**PRODUCT:** X-09™, CDX-09 and Cencon

**BULLETIN NUMBER:** MB013

## New Extended Change Key

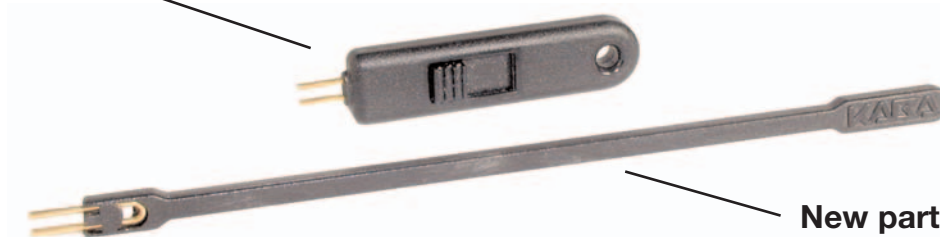
Kaba Mas has redesigned our change key and will begin shipping the new model with each Cencon, X-09 and CDX-09 lock ordered.

- Length is now 5" (127mm), compared with the previous 2" (52mm), allowing easier and quicker access to the back of the lock case.
- Width and depth have been reduced by 50%, allowing more space to work with through the opening in your container's door cover.
- Gold prongs remain permanently extended, preventing the need to keep your thumb on a switch during use.

**Obsolete part**

**New part**

\*Please note, the previous design of change key will continue to be compatible with existing and new locks. Never insert non-approved items into change key openings of lock. Use of substitute objects with sharp edges or without ESD-protection can damage the electronic card and will void the warranty.
